DATE: February 11, 2014
TO: Honorable Mayor and Members of the Village Council
FROM: John C. Gilbert, Village Manager
RE: Site Plan Review: 12-22-24 Crandon Boulevard and 51 Harbor Drive

DT: February 11, 2014
TO: John C. Gilbert, Village Manager
FR: Jud Kurlancheek, AICP, Director
Building, Zoning, and Planning Department
RE: Supplemental Site Plan Review Report and
Recommendation: 12-22-24 Crandon Boulevard and 51
Harbor Drive

DT: December 3, 2013
TO: John C. Gilbert, Village Manager
FR: Jud Kurlancheek, AICP, Director
Building, Zoning, and Planning Department
RE: Site Plan Review: 12-22-24 Crandon Boulevard
with access from 51 Harbor Drive

SHEET NUMBER: **C-1**

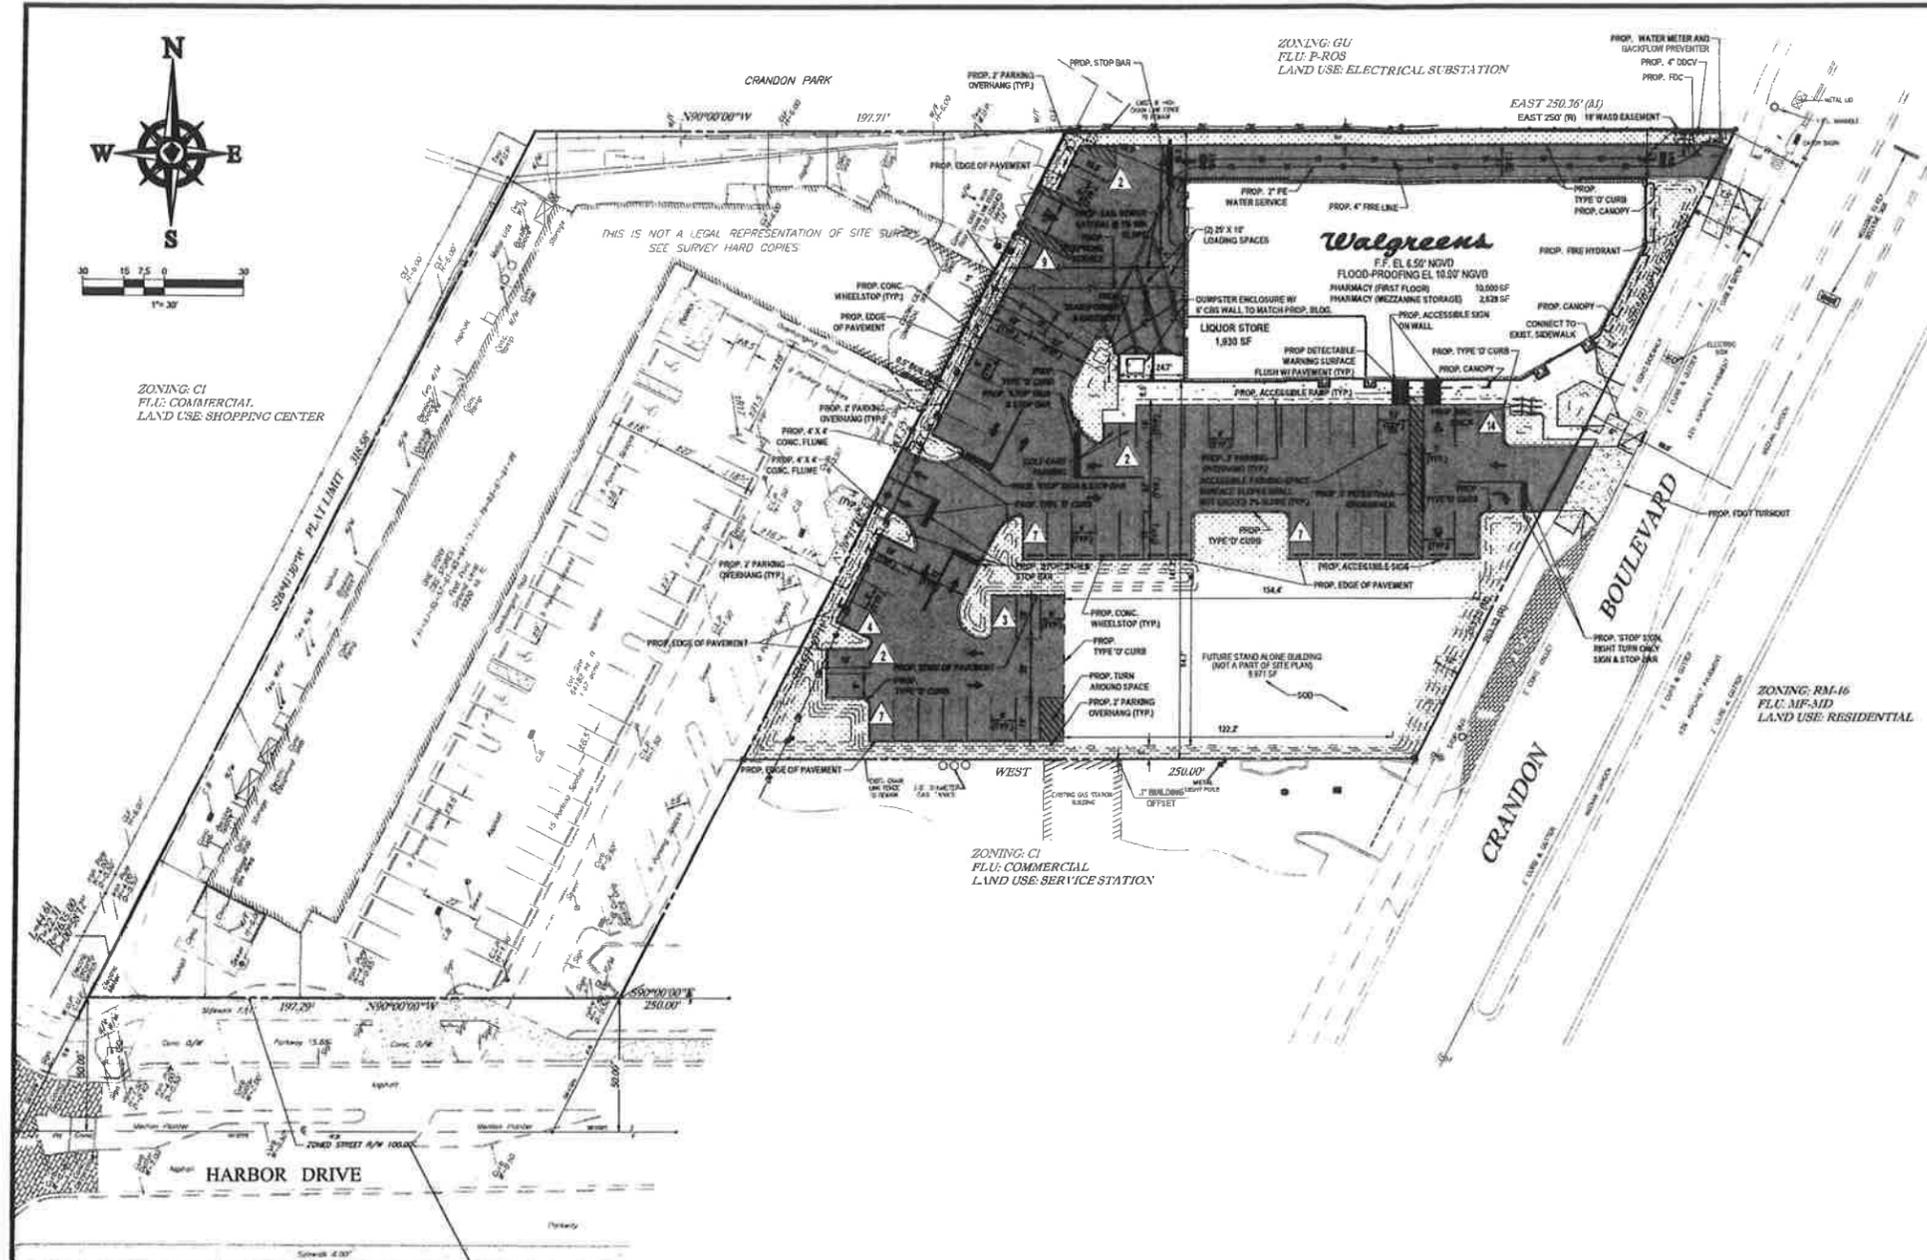
In addition, please provide a signed and sealed survey and a legend on sheet C-1 "Site Plan" explaining the symbols (E, S, T, and W) for the easements.

1. On Site Plan Sh. C-1, Floor Plan Sh. A1.11, and any sheet that references the mezzanine, change "Mezzanine" to "Mezzanine Storage", both in plans and tabulations.

4. Show surface material of the Future Building Area, i.e. sod.
5. Fill in texture along the north side pharmacy wall currently showing a void which could indicate a pass through window on all applicable plans, i.e. C-1, C-2, C-3, A1.11, L-1.

6. Label edging for the dead end of the parking lot adjacent to the Future Building Area on C-1 – Type D curb?
7. Per the Grading & Drainage Plan, Sheet C-2, runoff from 51 Harbor Drive is coming into the 12-22-24 Crandon Blvd. property at the west perimeter. Provide drainage divides to block runoff from 51 Harbor Drive.

CADD PLOT: 1226 SCALE: 1/8" = 1'-0" DRAWING NO.
VOID PLOT: DRAWN BY: G.V.L.P. DATE: 03/01/13 SUPERSEDES PLAN DATED: REVIEWED BY: A.C.S. II OF DWGS: **A2.11**

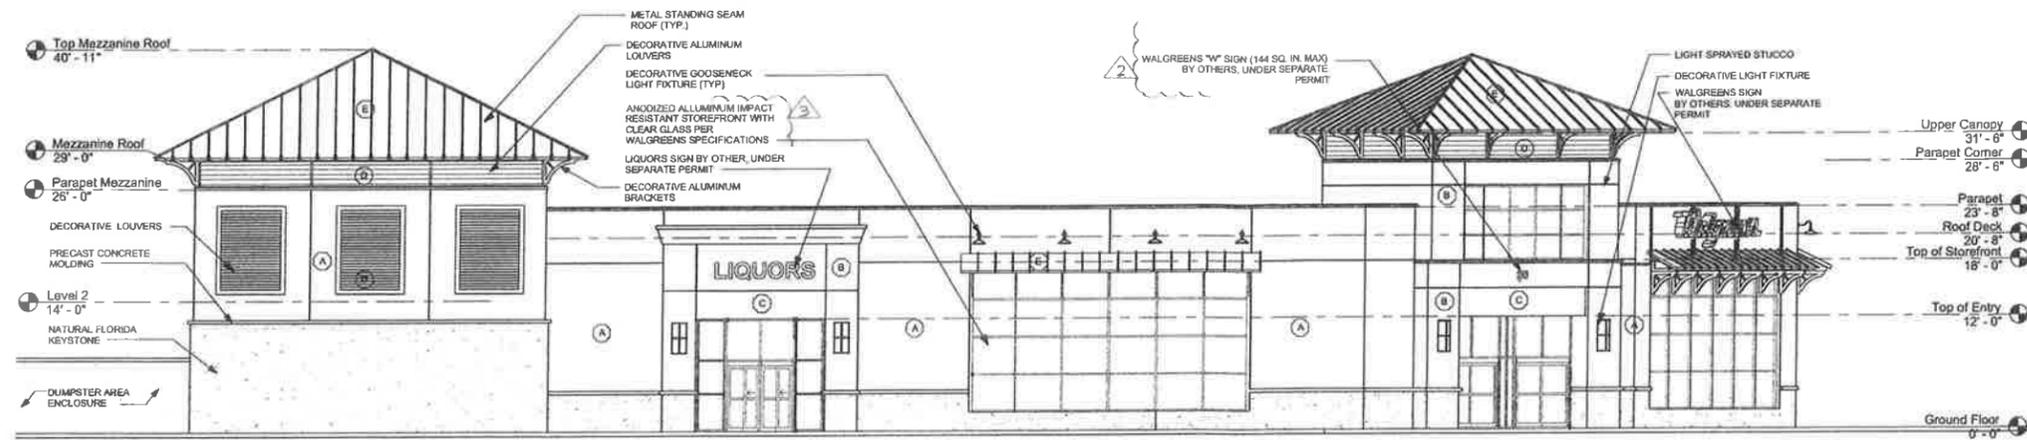
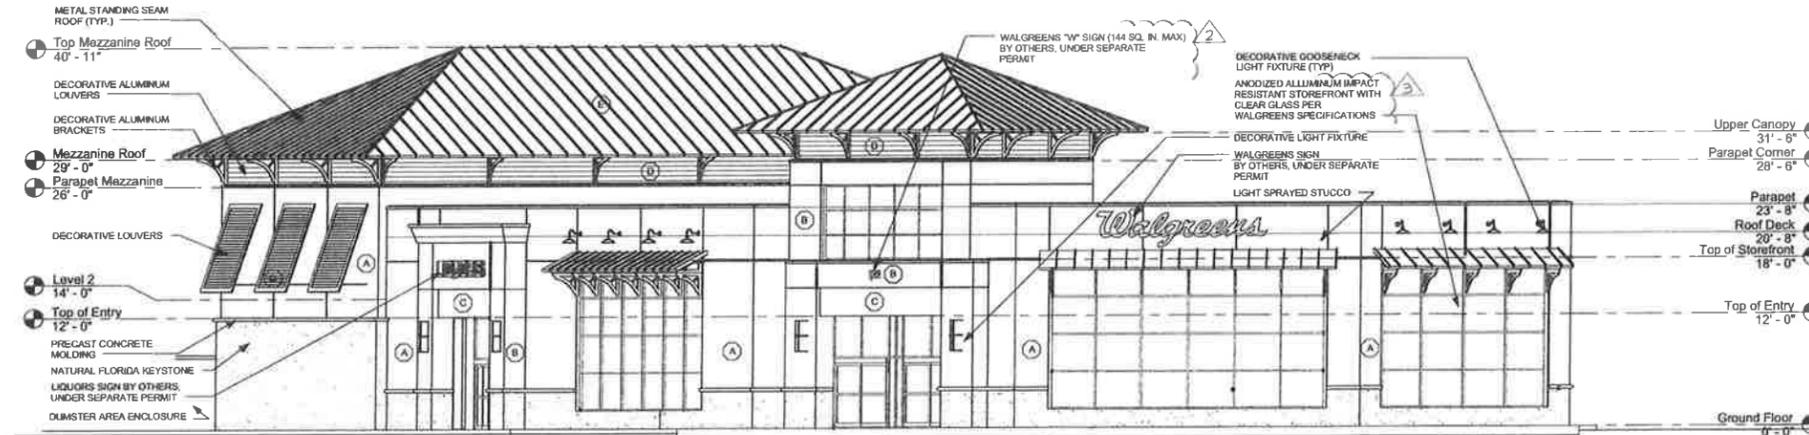
Analysis: Sheet A2.11 sets forth the color legend. The building utilizes Sherman Williams paint. The building will be painted cream and architectural elements will be pastels. The metal seam roof will be gray. The signs will be red which is the Walgreens trademark color. The building color scheme and finish materials provide for an appropriate background for the red Walgreens and Liquor signs which will be very visible from the street.
